Beaver Valley Power Station
Unit Nos. 1 and 2

License Amendment Requests
302 and 173

Extended Power Uprate

Subject: Beaver Valley Power Station, Unit No. 1 and No. 2
BV-1 Docket No. 50-334, License No. DPR-66
BV-2 Docket No. 50-412, License No. NPF-73
License Amendment Request Nos. 302 and 173

Figure 4.2-2
Reactor Coolant System Cooldown
Limitations Applicable for the First ~~22~~ 21 EFPY (TS 3.4.9.1)

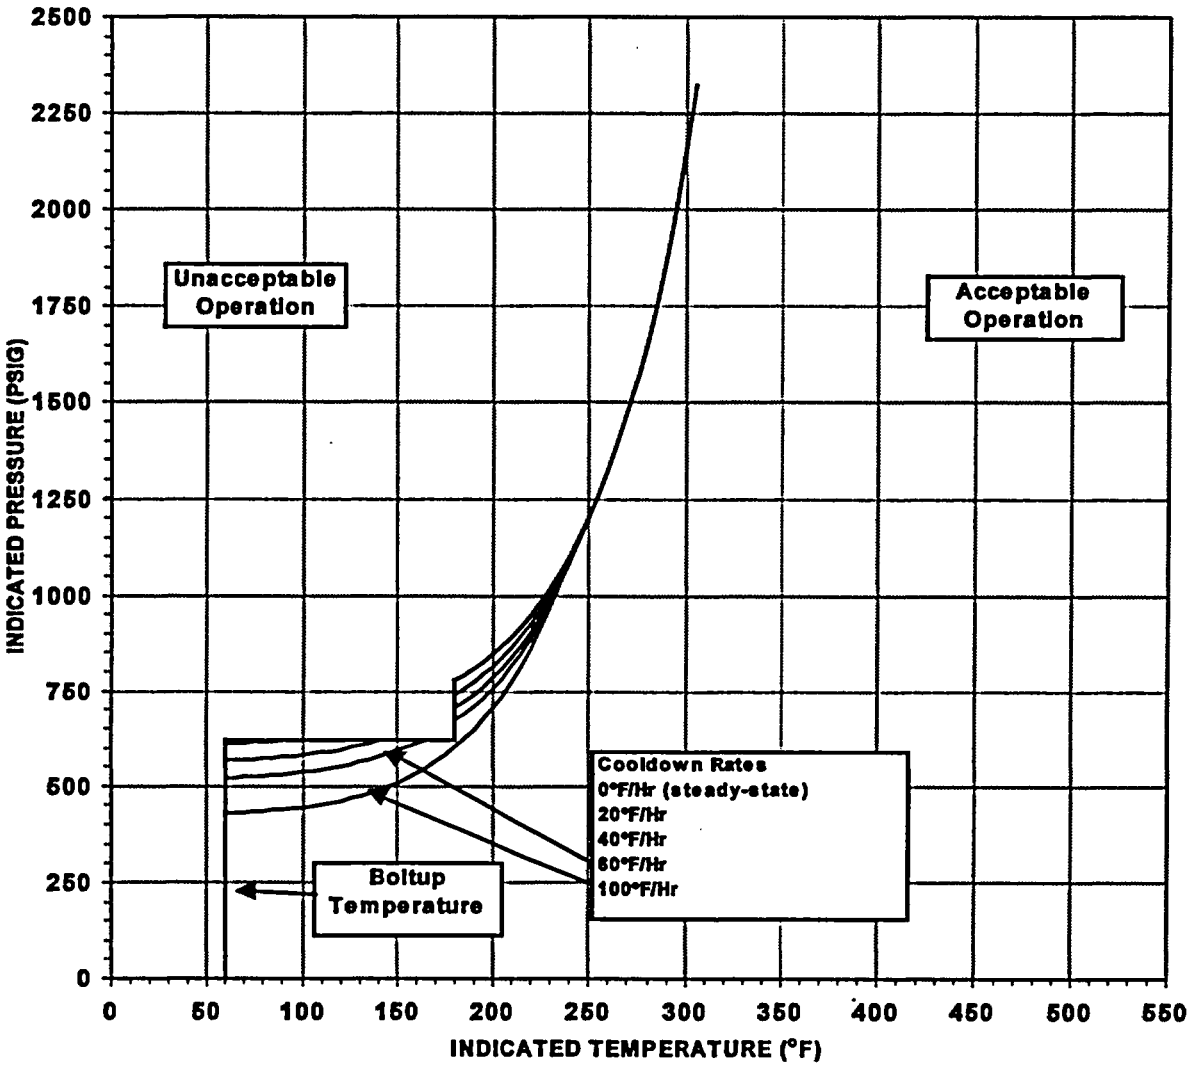
LIMITING ART VALUES AT ~~22~~ 21 EFPY: 1/4T, 233°F

FIGURE 4.1-4

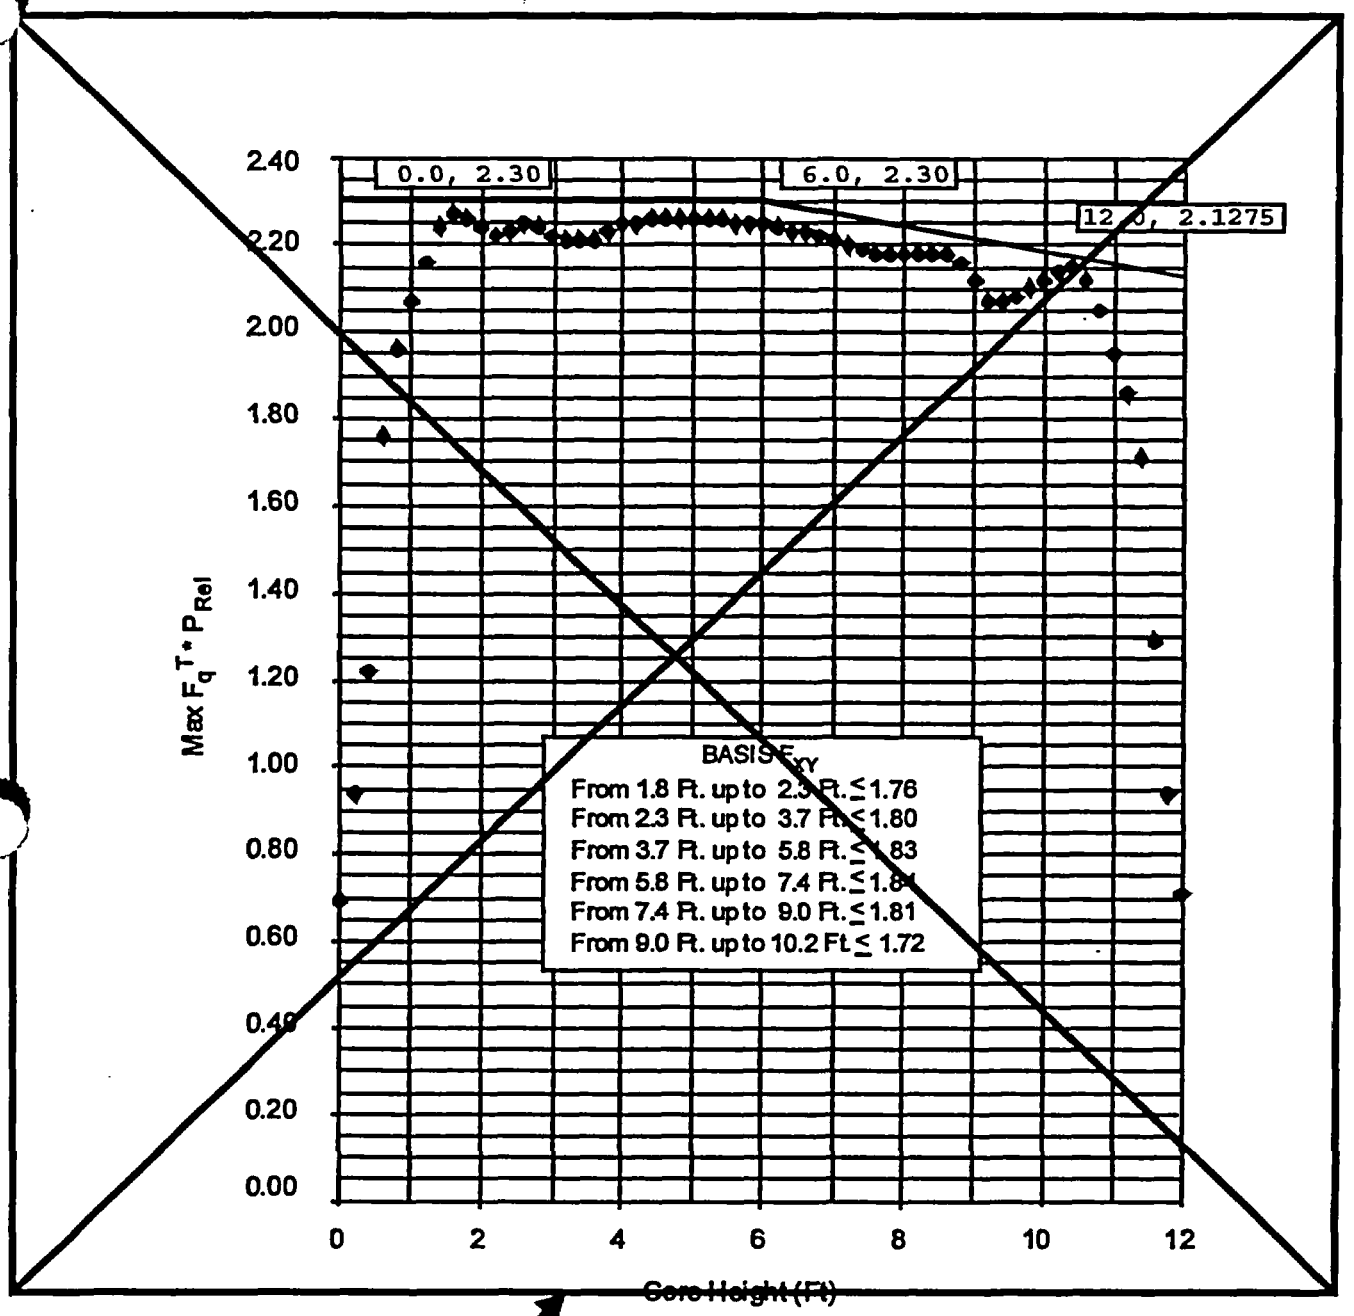
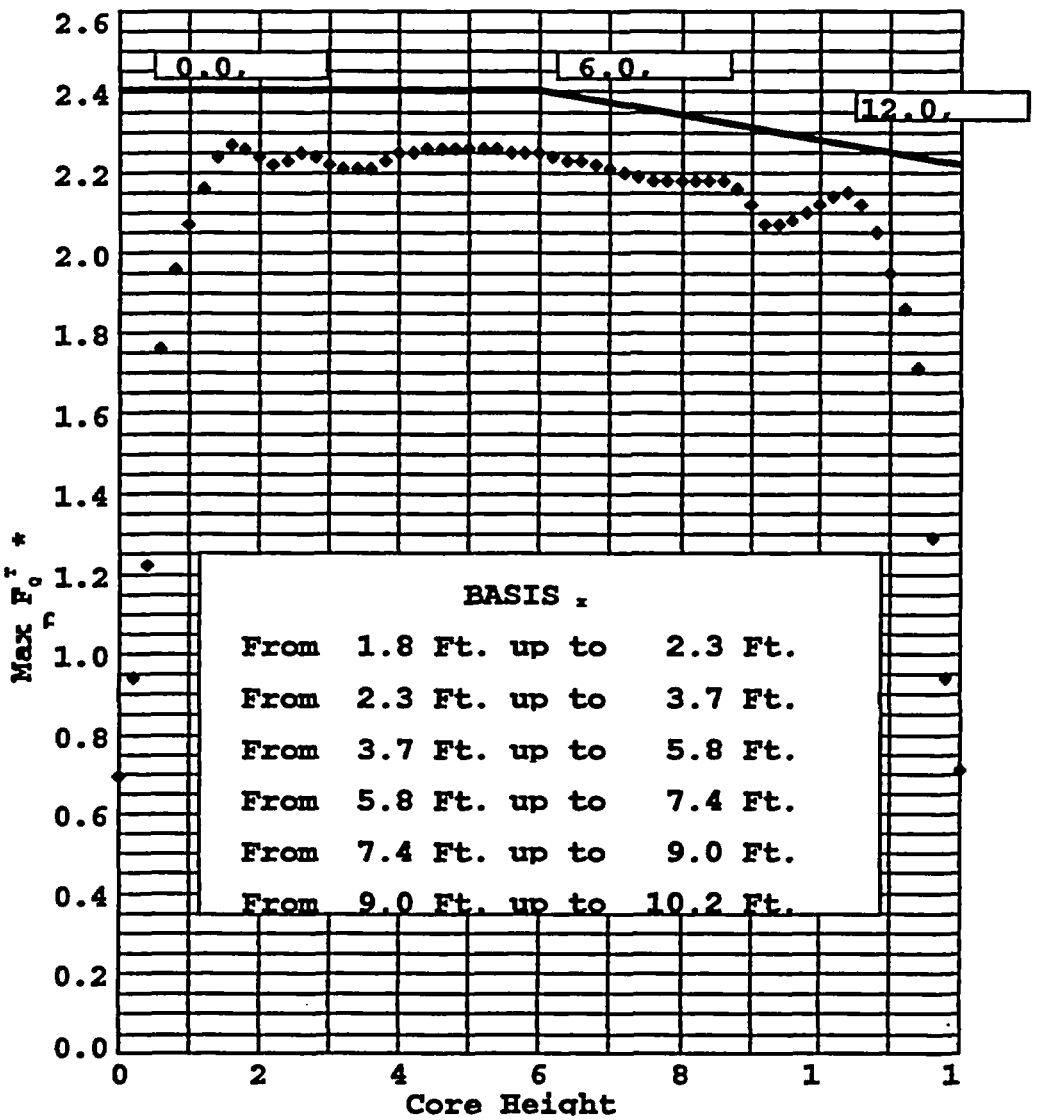
Replace with Insert C2-2.

Insert C2-2.

Figure 4.1-5
REACTOR CORE SAFETY LIMIT
THREE LOOP OPERATION
(Technical Specification Safety Limit 2.1.1)

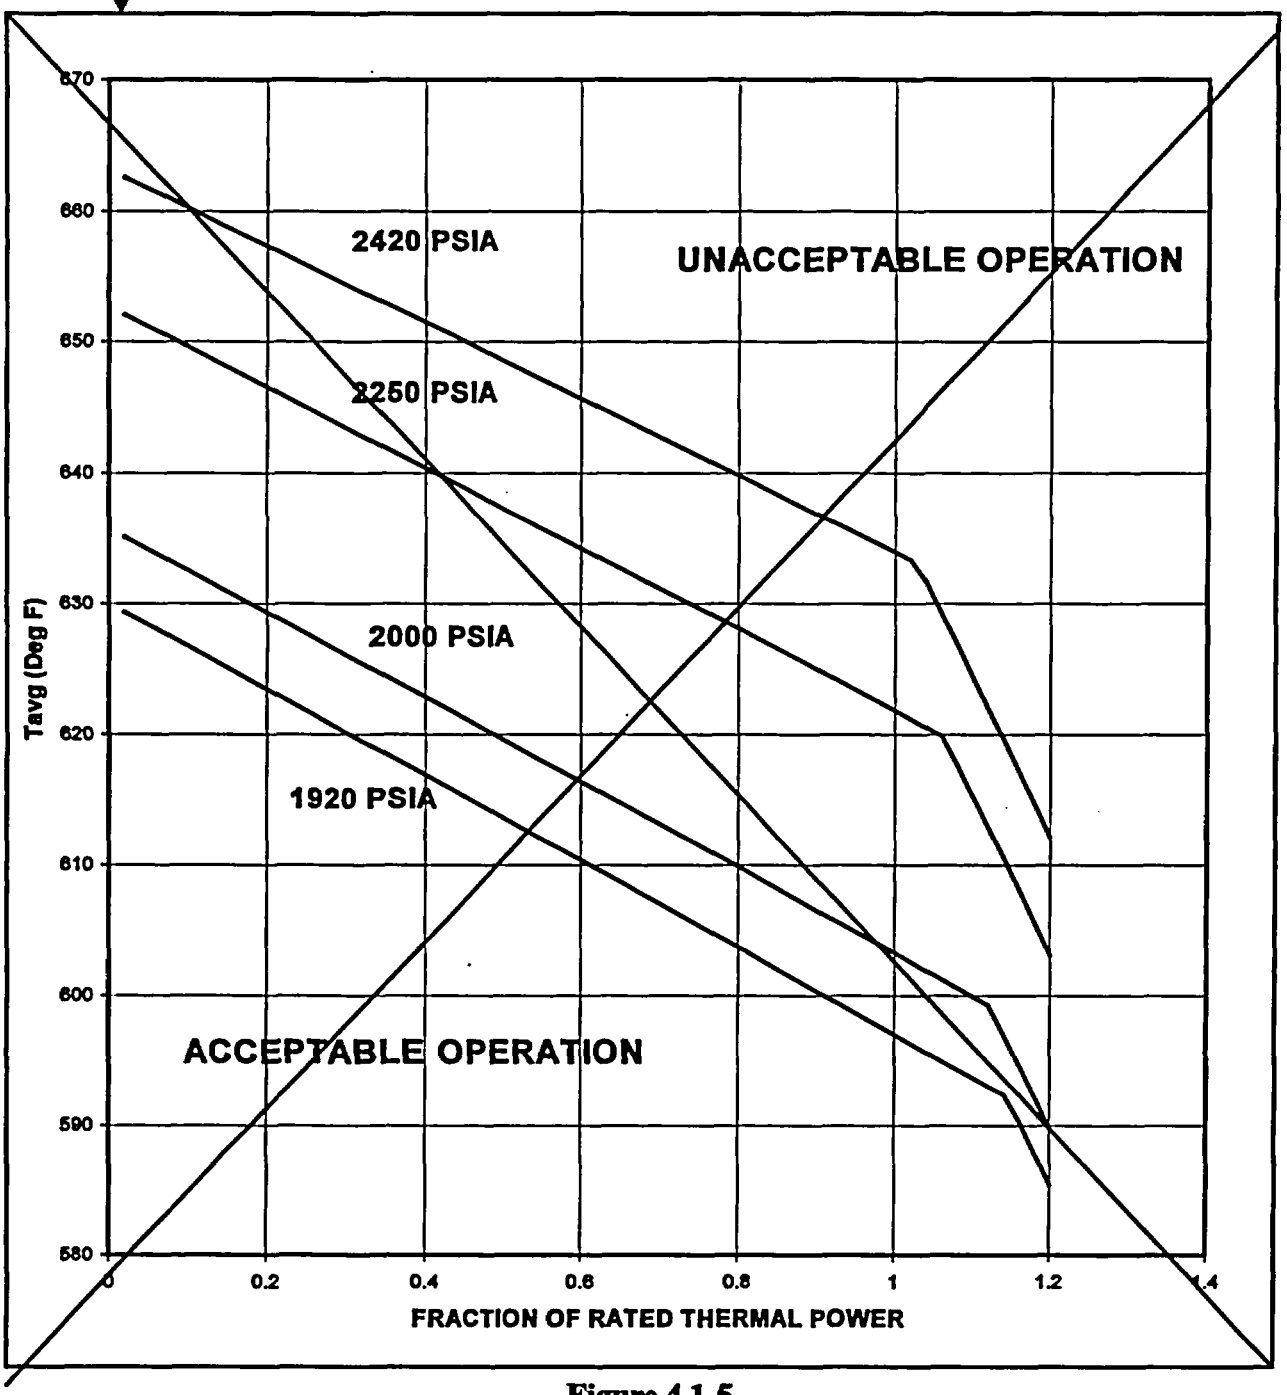
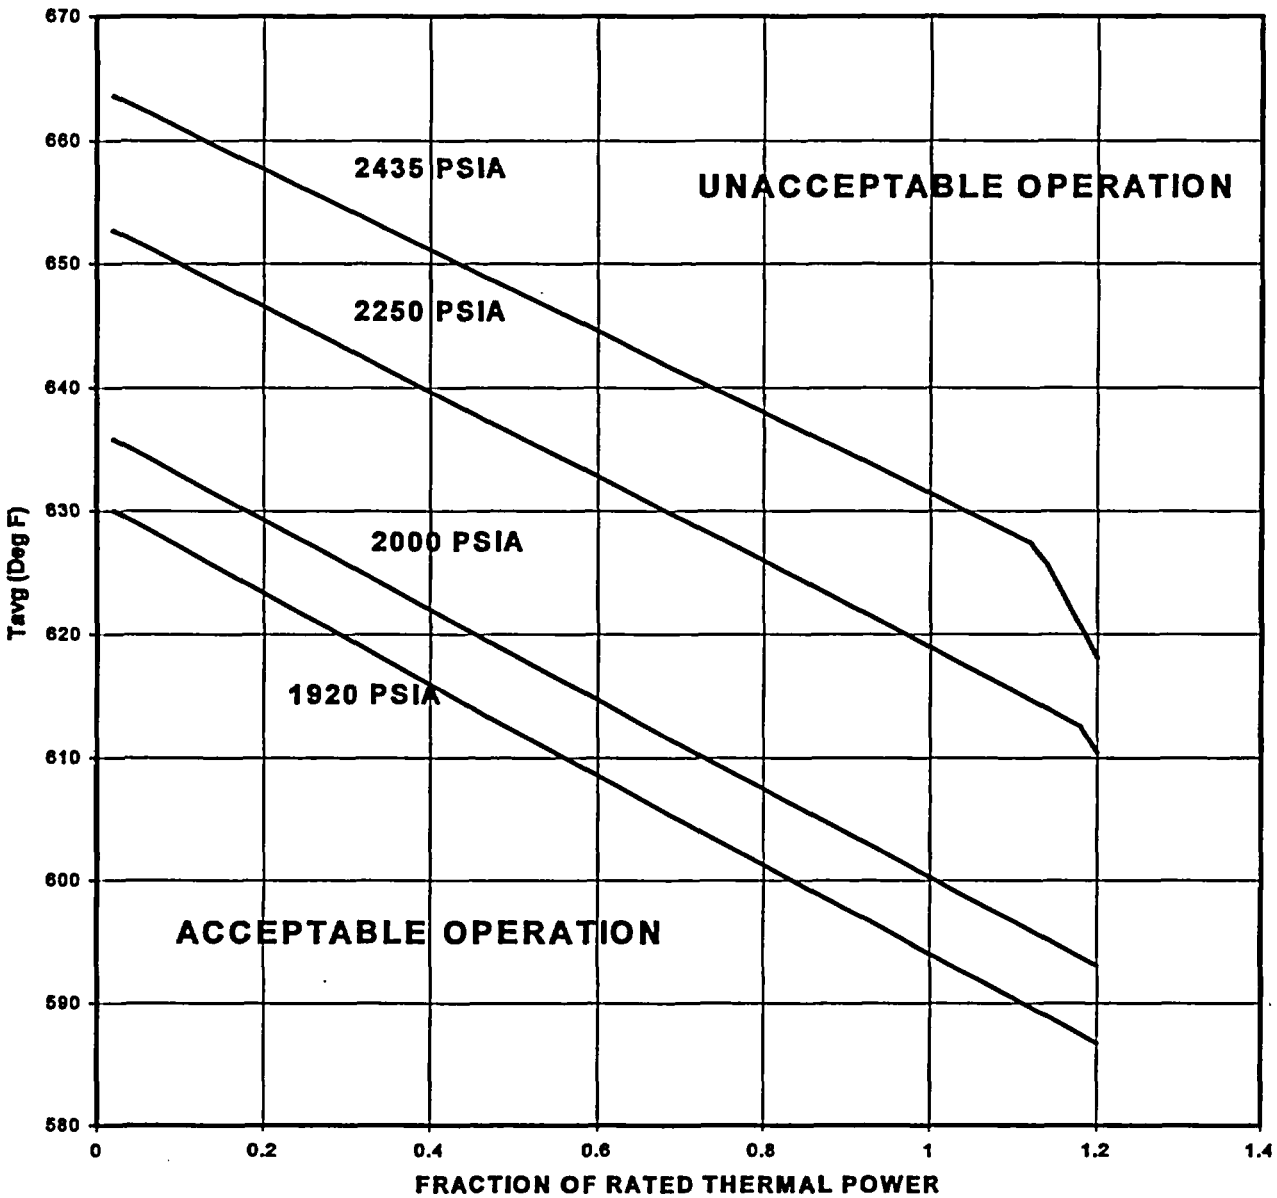
Replace with Insert C2-3.

Insert C2-3.

Figure 4.2-1
Reactor Coolant System Heatup
Limitations Applicable for the First ~~14~~22 EFPY (TS 3.4.9.1)

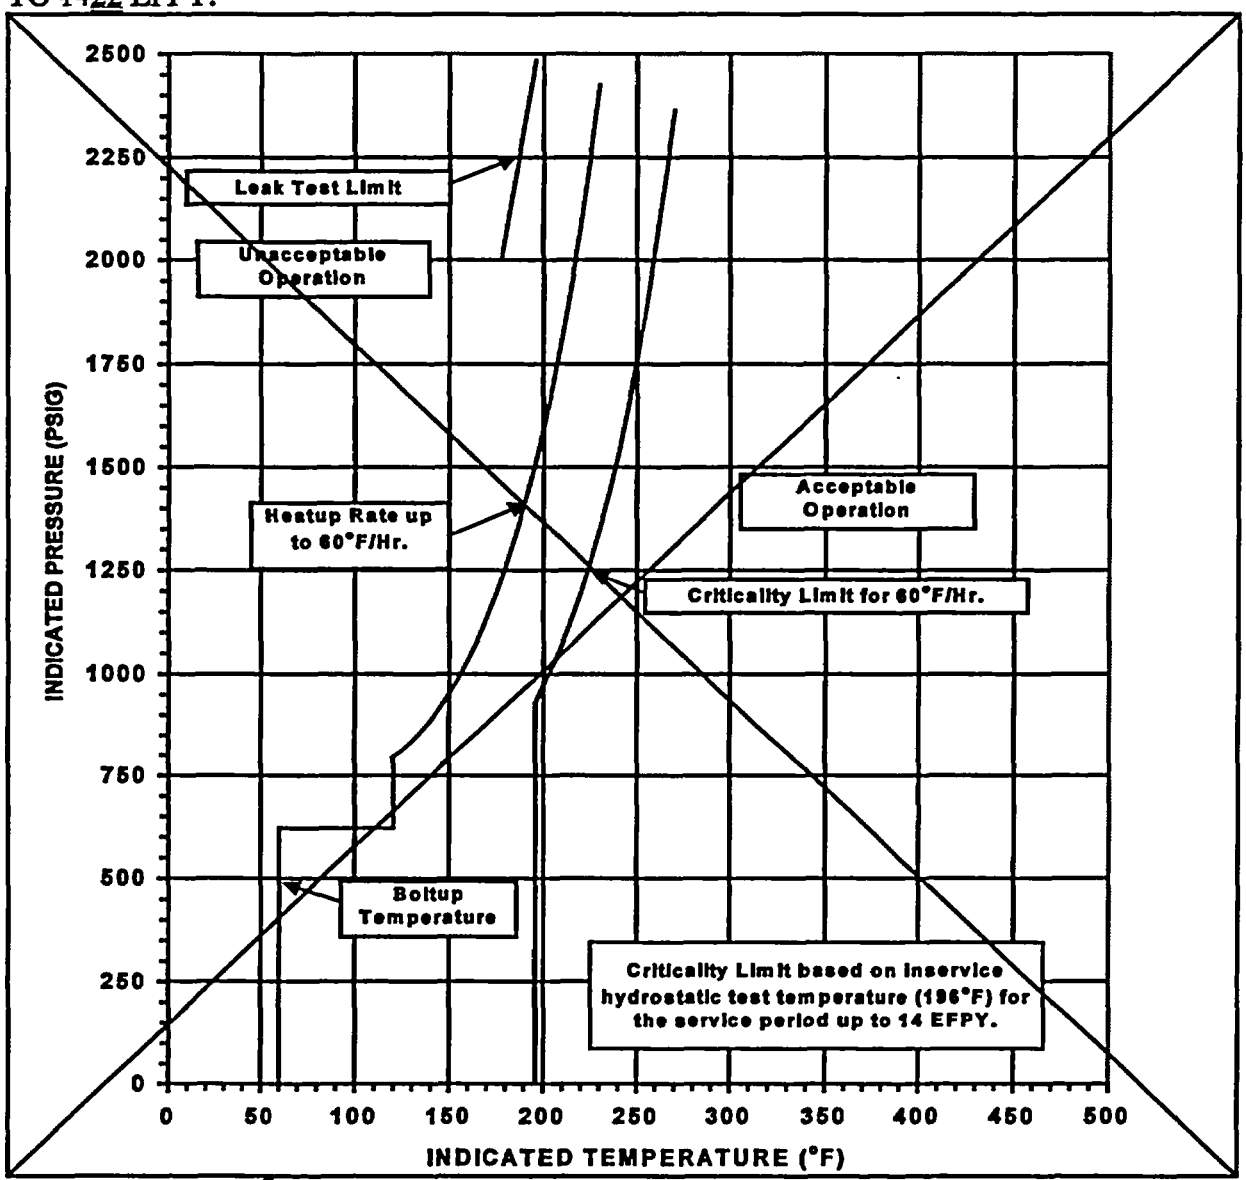
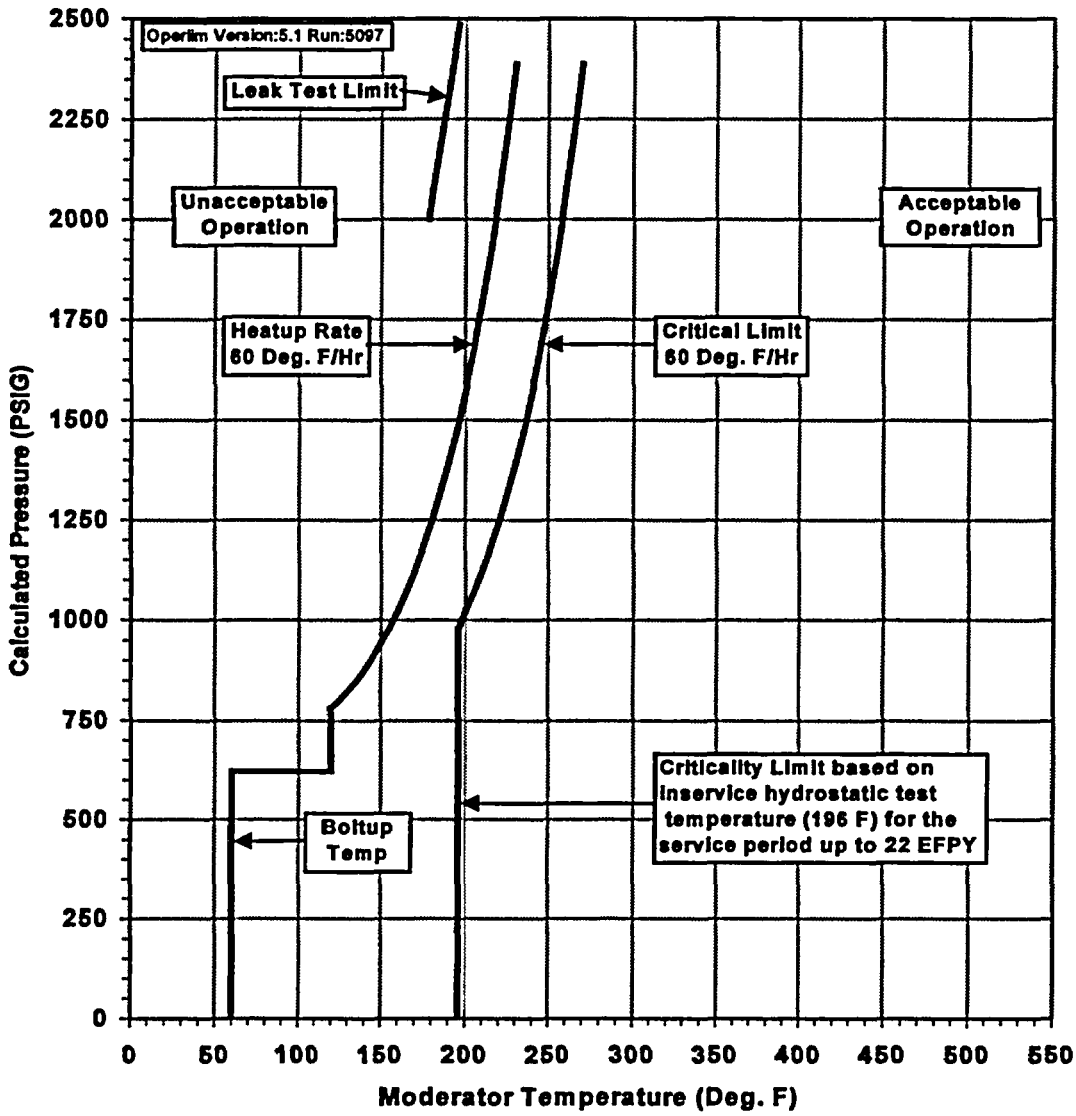
CONTROLLING MATERIAL:	INTERMEDIATE SHELL PLATE B9004-1
INITIAL RT_{NDT}:	60°F
RT_{NDT} AFTER ~~14~~22 EFPY:	1/4T, 140°F
	3/4T, ~~128~~129°F

Replace with Insert C2-4.

Insert C2-4.
